Access Compliance Report Public Rights-of-Way (Curb Ramps)

Main Street: ETON_PL Cross Street: BEACHMONT_AVE Location: NE

ADA ID: RPAT211006145340 Ramp Type: Type 1 - Perpendicular Diagonal Initial Pass/Fail: Fail Overall Compliance: No Severity Score: 16

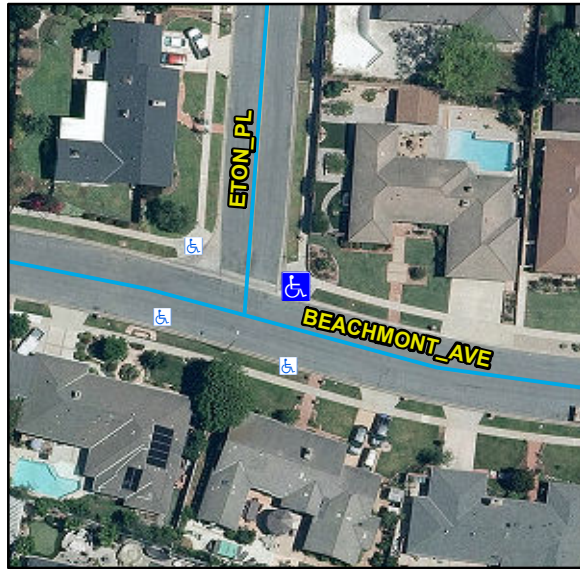
Compliance	Description	Data	Compliance	Description	Data
N/A	Ramp Length (in)	106	N/A	Flare Type LT	
Yes	Ramp Width (in)	52			N/A
No	Ramp Run Slope (%)	8.4	N/A	Flare Slope LT (%)	N/A
Yes	Ramp Cross Slope (%)	1.5	N/A	Flare Traversable LT	N/A
N/A	Landing Present	N/A	N/A	Flare Type RT	
N/A	Landing Length (in)	N/A			N/A
N/A	Landing Width (in)	N/A	N/A	Flare Slope RT (%)	N/A
N/A	Landing Run Slope (%)	N/A	N/A	Flare Traversable RT	N/A
N/A	Landing Cross Slope (%)	N/A	N/A	DWS Provided	N/A
N/A	Landing Movement Obstructed?	N/A	N/A	DWS Contrast	N/A
	Landing Movement Type	N/A	N/A	DWS Length (in)	N/A
N/A	Landing Shared	N/A	N/A	DWS Full Width	N/A
N/A	Clear Space	Yes	N/A	DWS Offset Left (in)	N/A
N/A	Clear Space To Crosswalk (in)	N/A	N/A	DWS Offset Right (in)	N/A
N/A	Marked Crosswalk 1	No	N/A	Marked Crosswalk 2	No
	Crossing 1 Direction	S		Crossing 2 Direction	W
	Marked Crosswalk 1 Width (in)	N/A		Marked Crosswalk 2 Width (in)	N/A

N/A	Ramp Inside Crosswalk 1	N/A	Yes	Ramp Inside Crosswalk 2	N/A
	Crossing 1 Slope (%)	0.1		Crossing 2 Slope (%)	5.2
	Crossing 1 Cross Slope (%)	2.1		Crossing 2 Cross Slope (%)	0.8
N/A	Gutter Ponding	N/A	No	Curb Slope	6.6
Yes	Gutter Lip Height (in)	0		Road Run Slope (%)	0.6
N/A	Gutter Run Slope (%)	N/A		Road Cross Slope (%)	2.9
N/A	Gutter Cross Slope (%)	N/A			
Yes	Overall Surface Condition: Acceptable		Yes	Perp Joint Present	Yes
	Cross Gutter Present?	Yes		Spandrel Present?	Yes
	Replace Cross Gutter?	No		Replace Spandrel?	No

Remove & Replace Curb Ramp With Two New Directional Ramps or Equivalent.
